Subject: **CORRECTING UNEVEN BRIGHTNESS**

Model: **BVM-8044/9044/9044D**

Serial No: **2,000,001–2,000,200 (BVM-8044)**
2,000,001–2,000,070 (BVM-9044)
2,000,001–2,000,400 (BVM-9044D)

Figure 1

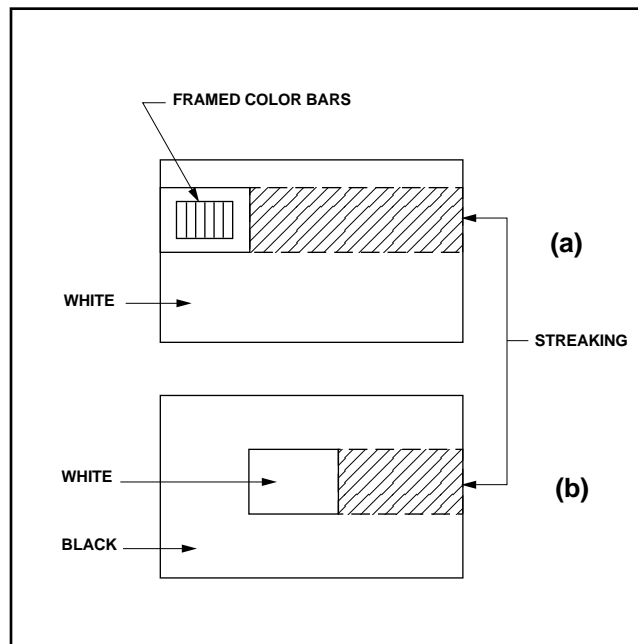
When an SDI signal is input, picture brightness may undulate or appear streaked. This effect may occur in

- the white area to the right of framed color bars as shown in Figure 1 (a), or
- the black area to the right of a white window as shown in Figure 1 (b).

To minimize this condition, perform the following modification procedure.

Figure 2

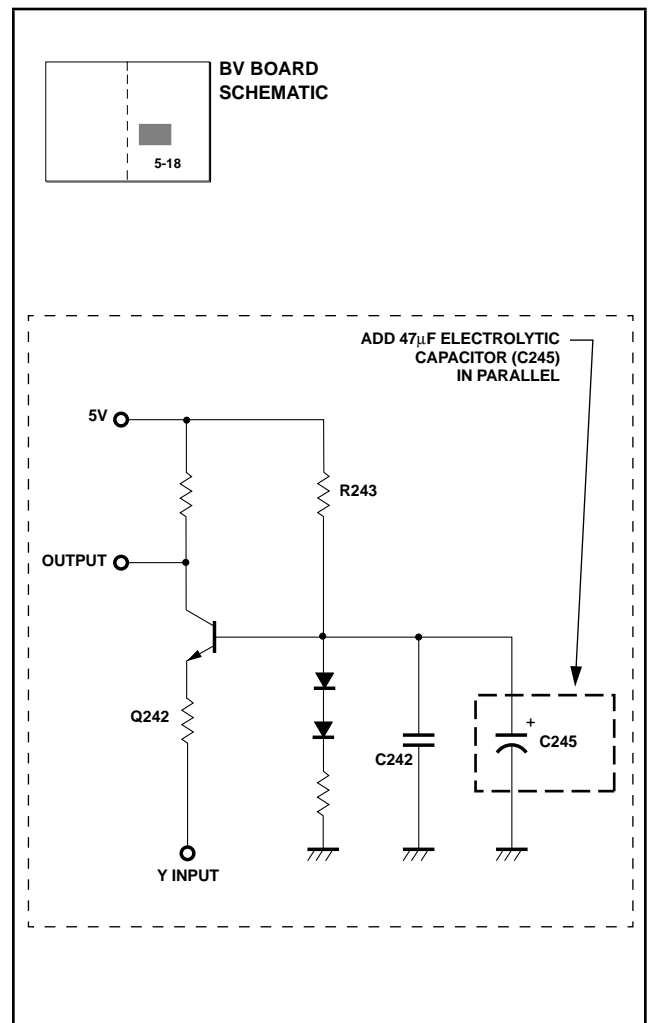
1. Replace R182 on the B board (component side, zone C-11) with a 20kΩ chip resistor
2. Solder a 47μF electrolytic capacitor (C245) on the BV board (solder side, zone B-3) in parallel with C242. (See Figure 2.)
